RUDDEN RESIDENCE
6064 OLD LAWYERS HILL RD.
ELKRIDGE, MD 21227

LOT 6
MEHRING PROPERTY (RESUB)
PLAT BOOK 7415

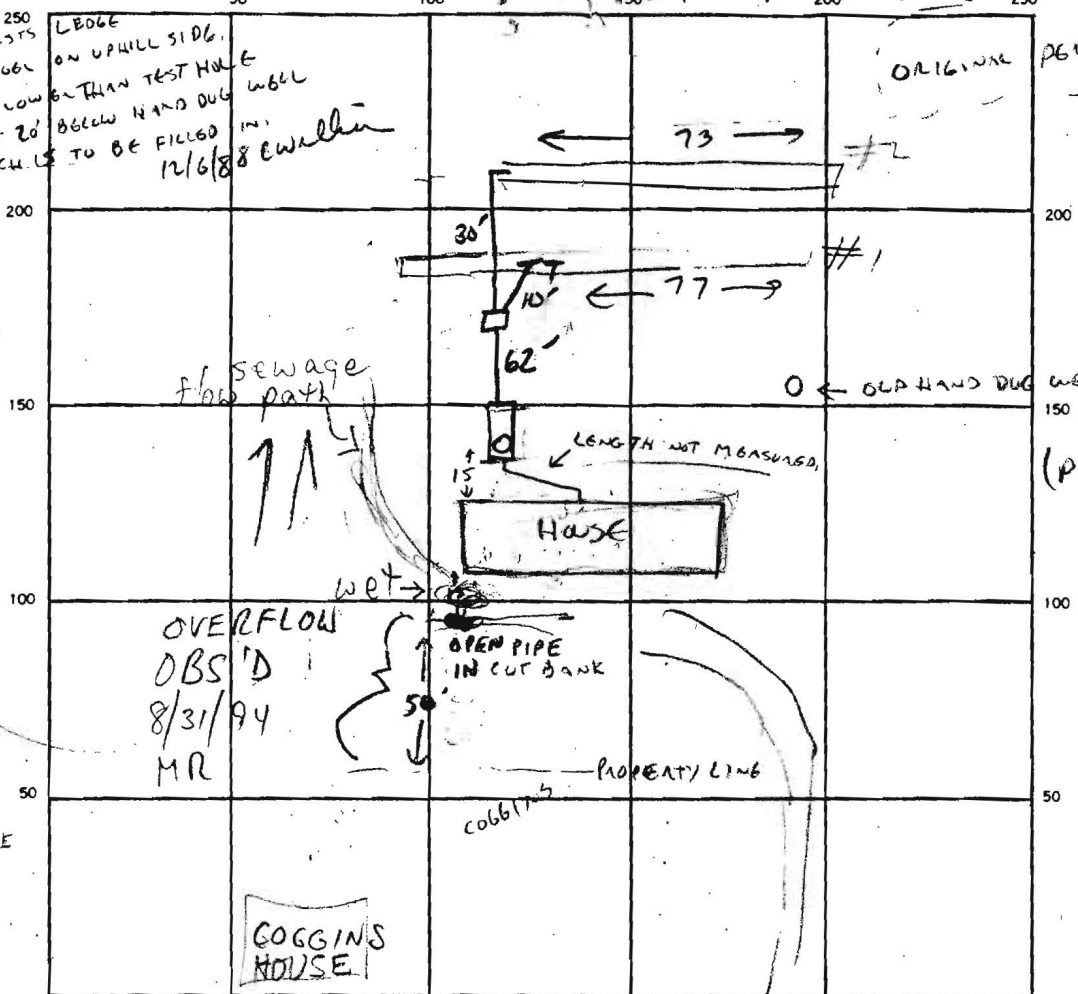
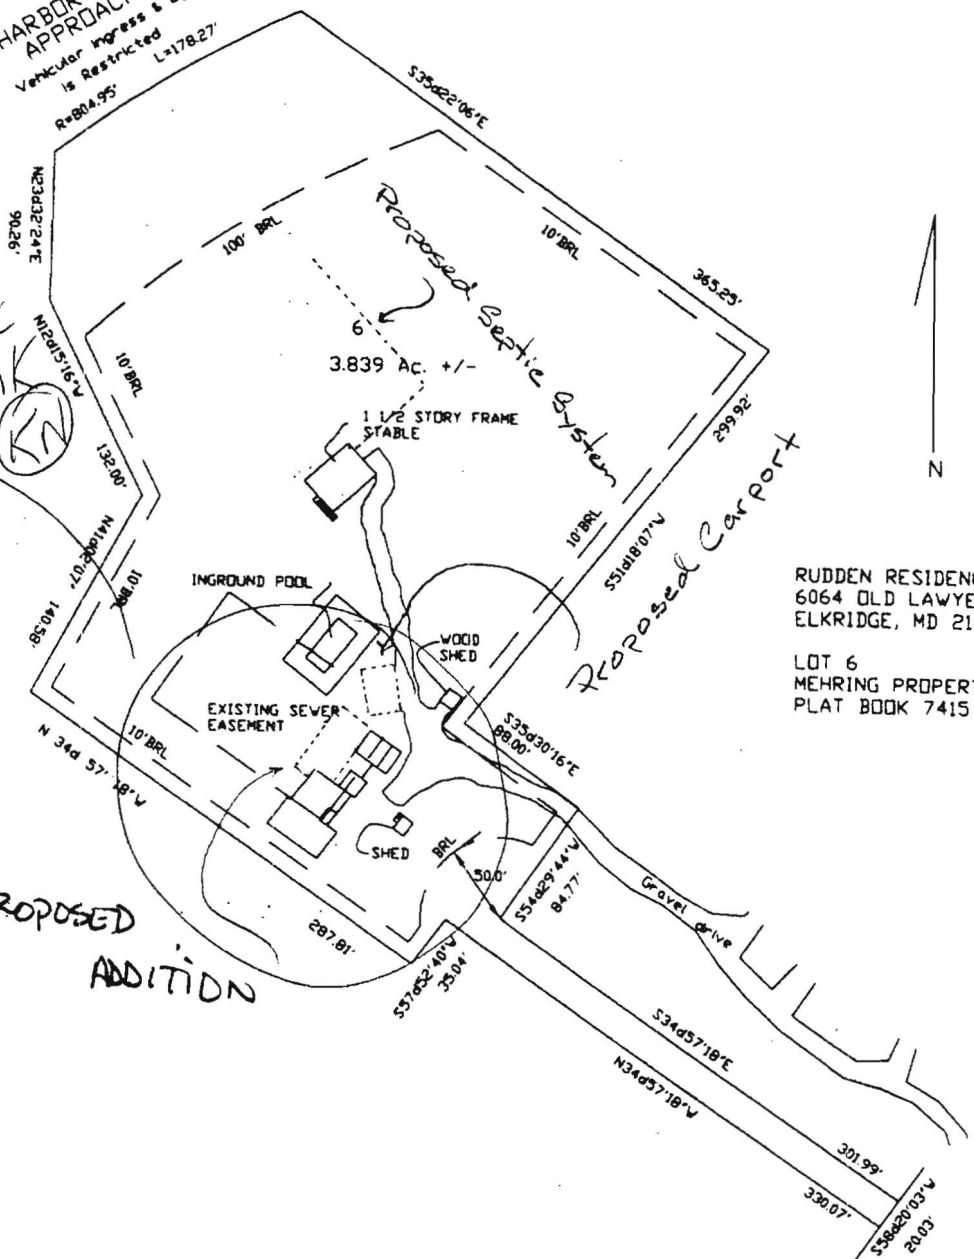
ROCK LEDGE AT 5' ON HIGH SIDE OF TEST HOLE
 TERMINAL SUGGESTS MAY BE STRONGER
 INSTALL SYSTEM LOW THAN TEST HOLE AND AT LEAST 20" BELOW HAND DUG WELL WHICH IS TO BE FILLED IN.
 12/6/88 CWL

CLAY
 CLAY LOAM & MICA LOAM MIX.
 3
 12
 INSTALL 150' TRENCH IN LOT 3' BOTTOM 7' WITH 4" STONE

REMARKS 11/17/88 OLD SYSTEM TO BE REPLACED PERC HOLES PUG IN 1977.
ABOUT 150 FT BE HIND OLD HOUSE. 2 VISUAL HOLES TO BE DUG
AT TIME OF SEPTIC INSTALLATION TO ALTER LOCATION OF TRENCH
VISITED SITE TODAY & TALKED TO PLUMBER & BUILDER. ALSO OLD HAND DUG
WELL MUST BE FILLED IN BY 12/1/89 - TRENCHES DUG TANK SET BUT NOT
CONNECTED. FINISH JOB & COVER BY 12/13/88 OK TO COVER FROM TANK TO TRENCH
